RE: CHARLES STREET AT FELL AVENUE
(Item 22, Report No. 47, 1988 July 11)

SUBJECT: CHARLES STREET AT FELL AVENUE

PURPOSE: The purpose of this report is to provide Council with the Approving Officer's conclusions in reviewing the extension of Charles Street through to Fell Avenue in connection with the subdivision application of the adjacent property to the north.

ITEM 6
 MANAGER'S REPORT NO. 55
 COUNCIL MEETING 88/09/06

S.D. REF. # 49/88
 X. REF. S.D. REF. # 88/85
 ZONING: R4

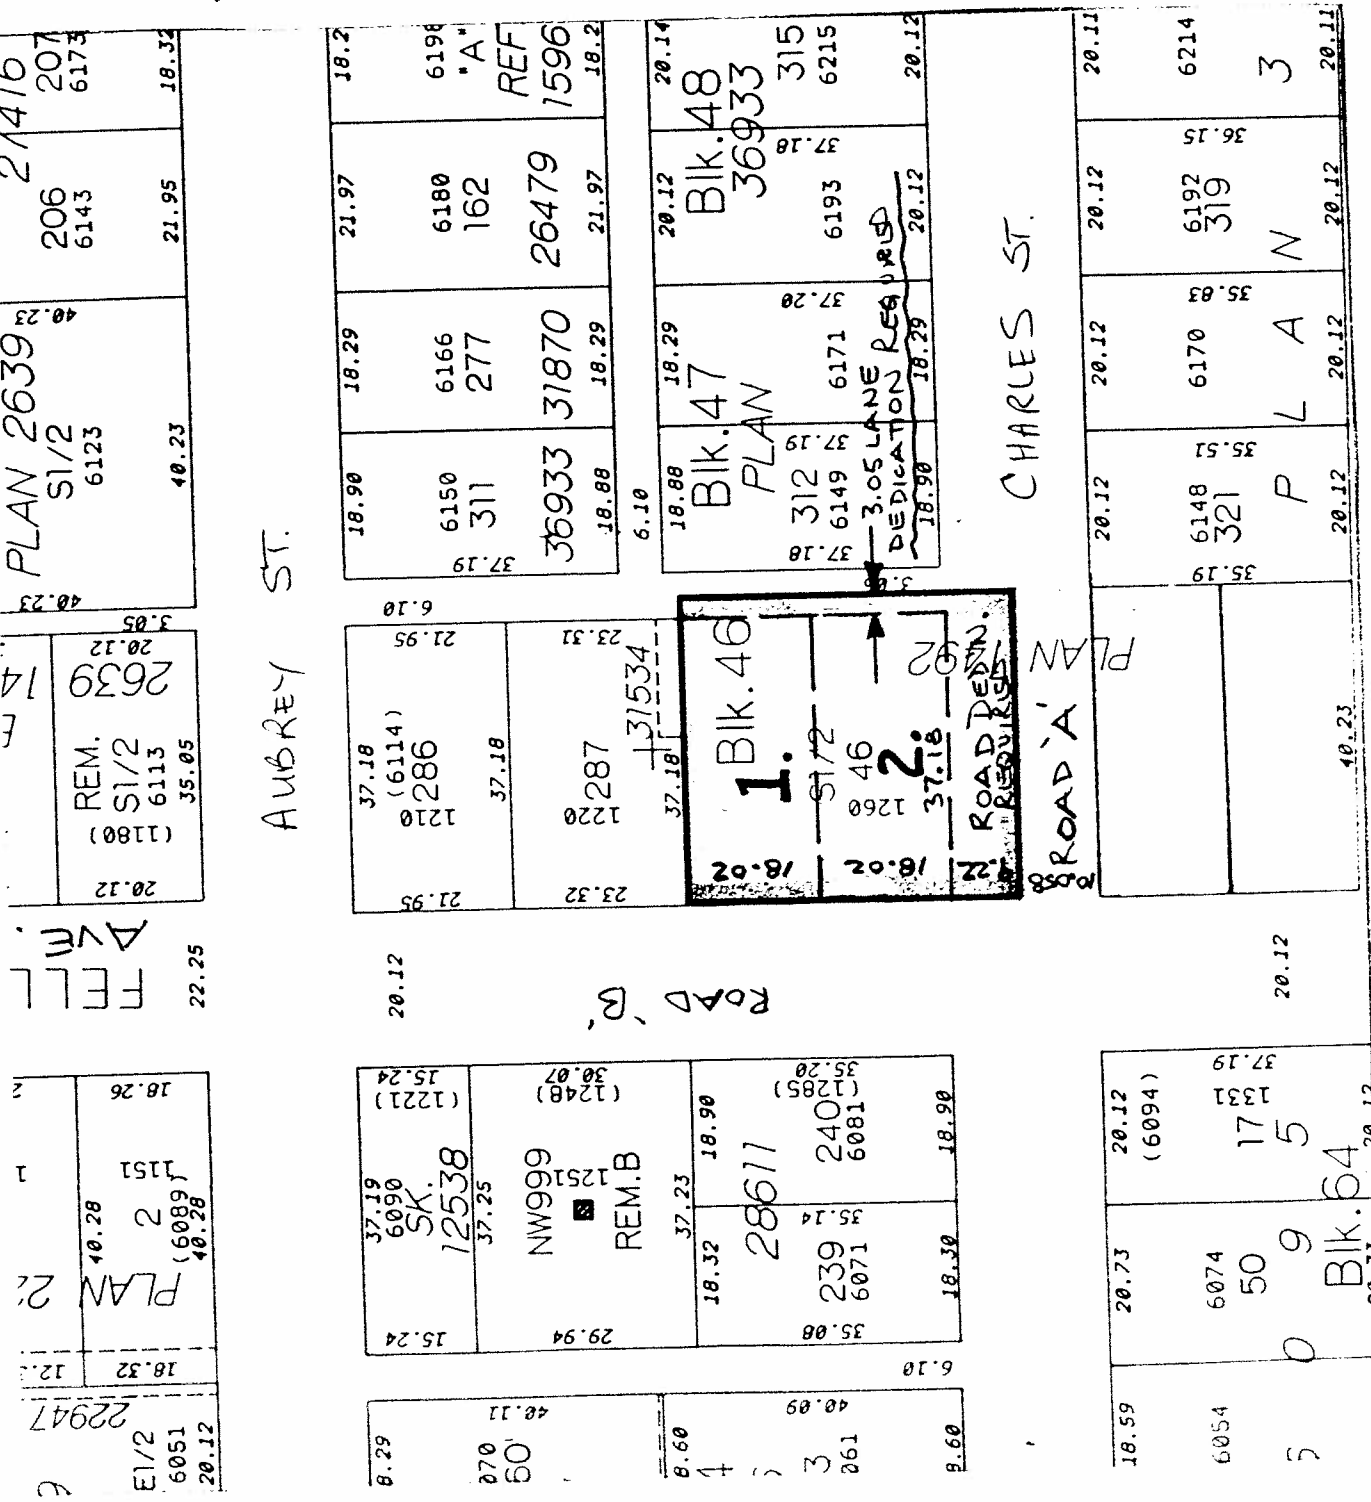
After reviewing the matter of providing an alternative to extending Charles Street through to Fell Avenue, it has been determined that a standard "hammerhead" turnaround would need to be constructed in the Charles Street road allowance between Fell Avenue and the lane to the east (adjacent to proposed Lot 2 as shown on the attached sketch), together with a fire truck emergency access linking Fell Avenue with Charles Street. The subdivider would be responsible for providing this turnaround and emergency access link, as well as dedicating the full Charles Street road allowance at this time and submitting engineering design drawings and monies "In Trust" for the possible extension of Charles Street through to Fell Avenue in the future.

It should be noted that the "hammerhead" turnaround would be substandard as there is insufficient area within the property proposed for subdivision to provide further dedication for a standard turnaround, while still maintaining the minimum lot area required for the two proposed lots.

In reviewing this alternative, the Approving Officer has concluded that Charles Street be extended through to Fell Avenue as a condition of subdivision approval based on the following considerations:

- (a) A cul-de-sac length exceeding 500 feet is undesirable and is avoided where possible because of emergency vehicle access concerns.
- (b) Charles Street is approximately 1,100 feet in length and it is not appropriate to simply dead end the street or allow a substandard turnaround to be constructed.

The Approving Officer, in reviewing the recent subdivision application, together with the matters raised by the Charles Street residents and members of Council, has concluded that the extension of Charles Street through to Fell Avenue should be required as a condition of subdivision approval.
